ATTACHMENT 2 TO AEP:NRC:1071A

Proposed Revised

Technical Specification Page

Regarding a Non-Conservative Reactivity Evaluation

Figure 3.1-3 REQUIRED SHUTDOWN MARGIN

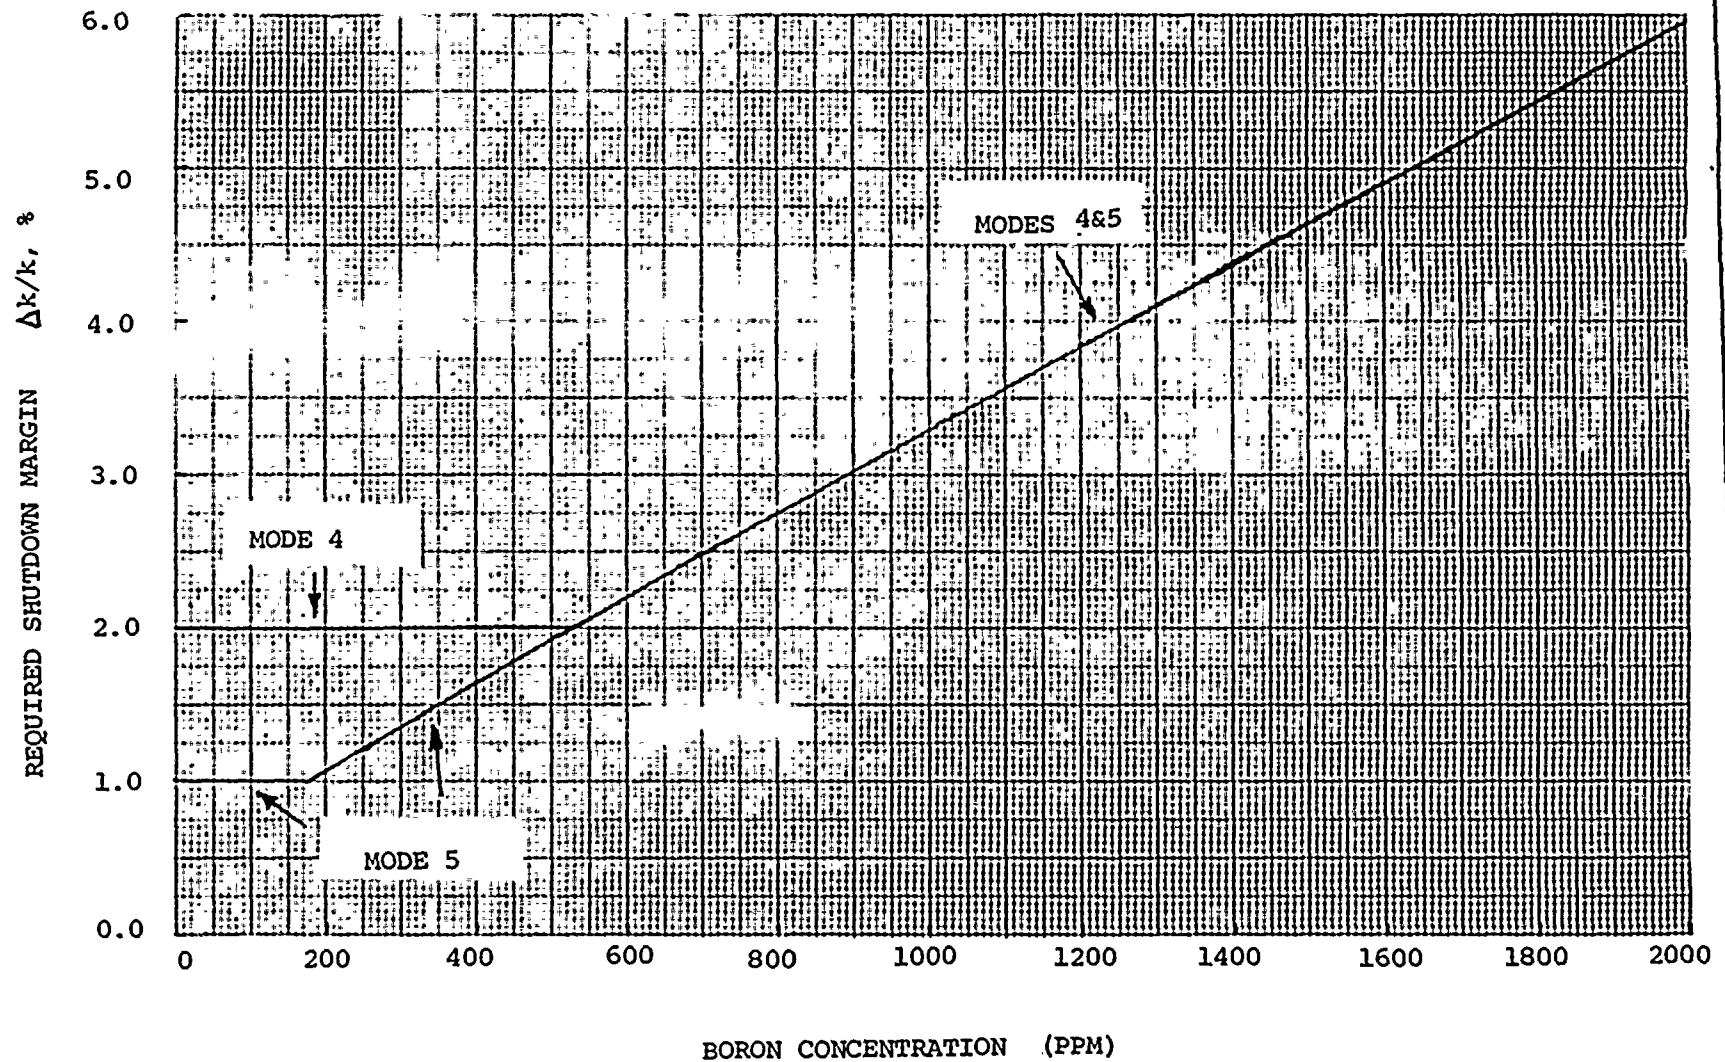
Recent review of the boron dilution transient analysis (Ref. 1) for the D.C. Cook Unit 2, Cycle 7 Safety Analysis Report revealed that the equation used to estimate the required shutdown margin when using the residual heat removal system (RHR) in Modes 4 and 5 was incorrect. This equation was used to establish Figure 3.1-3 of the D.C. Cook Technical Specifications for Cycle 6. The shutdown margin for Modes 4 and 5 during RHR cooling is based on providing sufficient operator response time, 15 minutes, to terminate an asymmetric boron dilution event. An asymmetric boron dilution occurs when unborated water is assumed to flow into only one coolant loop.

A review of the Cycle 6 analyses indicated that there was sufficient conservatism in the Technical Specification curve and in the implementation of this requirement in the Startup and Operations Report (Ref. 2) to preclude criticality during a potential asymmetric boron dilution event. This conclusion is based on a comparison of Cycle 6 Modes 4 and 5 RHR shutdown margin boron concentration requirements specified in the Startup and Operations Report (Figure 6.2) and the critical boron concentrations. Both the shutdown margin and critical boron concentrations were calculated with the NRC approved XTGPWR code. The comparison indicated that sufficient shutdown boron concentrations were required to insure that the plant would not become critical in less than 15 minutes. Thus, the plant did not have the potential for operating in an unanalyzed condition during Cycle 6. A modification to Technical Specification Figure 3.1-3 is recommended for Cycle 7.

for Cycles 6 and 7 are similar, the Cycle 6 results are conservative with respect to Cycle 7. A proposed Technical Specification Figure 3.1-3 is shown in Figure 2 and was obtained by conservatively adding 0.5 % $\Delta K/K$ to the calculated (XTGPWR) Cycle 6 shutdown values. This 0.5 % $\Delta K/K$ is included to cover cycle to cycle variations. Selected data-points are presented in Table 1.

Figure 1 Shutdown Margin Comparison from Reference Analysis and XTG Approximation (Cycle 6)

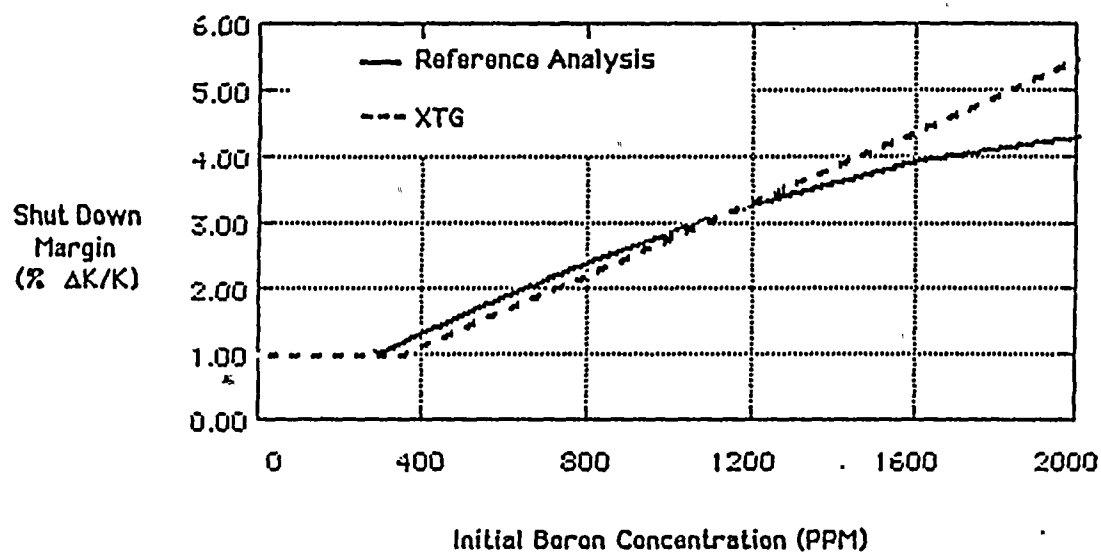
Because of these uncertainties, neutronic calculations were used to determine the required shutdown margin verses initial boron concentration and operating temperature. These calculations were performed with the NRC approved neutronics code, XTGPWR, which is ANF's standard neutronics code for performance of reload neutronics calculations. The difference between the Reference shutdown margin and the shutdown margin determined using the XTGPWR calculations for Cycle 6 is shown in Figure 1.

Figure 3 Conservatism in Operating Boron Requirement

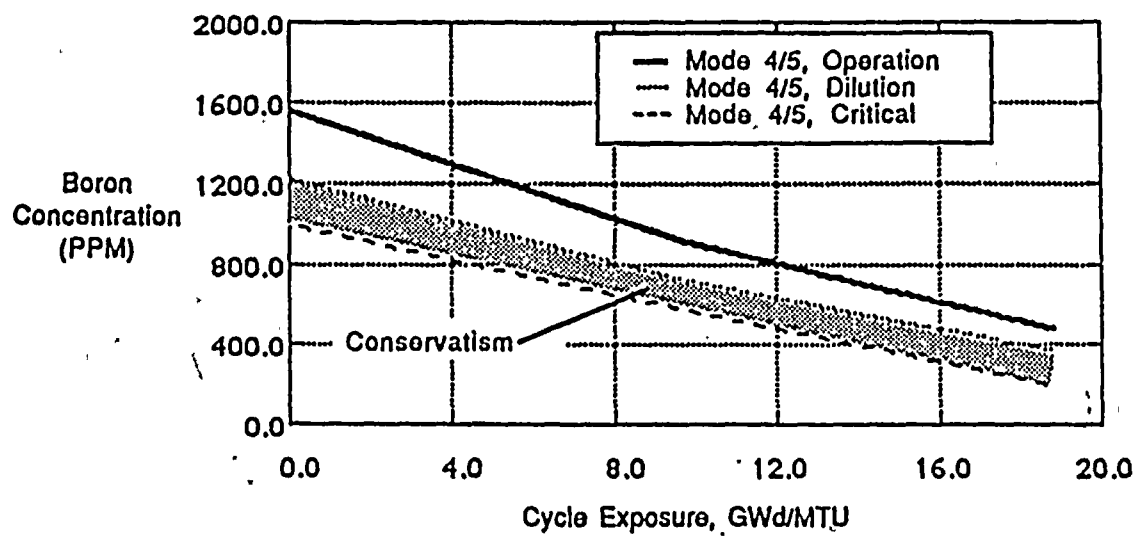
The requirements of Technical Specification Figure 3.1-3 are implemented conservatively through a curve of required boron concentration verses burnup. This curve was provided for D.C. Cook Unit 2 Cycle 6 in the Startup and Operations Report, XN-NF-86-63(P), Rev. 1. The magnitude of the conservatism in the required boron levels is seen from the curves presented in Figure 3. The curve labeled "Mode 4/5, Operation" is the required boron concentration verses burnup for plant operation in Modes 4 and 5 (from Ref. 2). The curves labeled "Mode 4/5, Dilution" and "Mode 4/5, Critical" compare the boron concentration after 15 minutes dilution to the critical boron concentration. From the figure, it is seen that sufficient boron is available at all boron concentrations to preclude criticality during a potential Boron Dilution event.
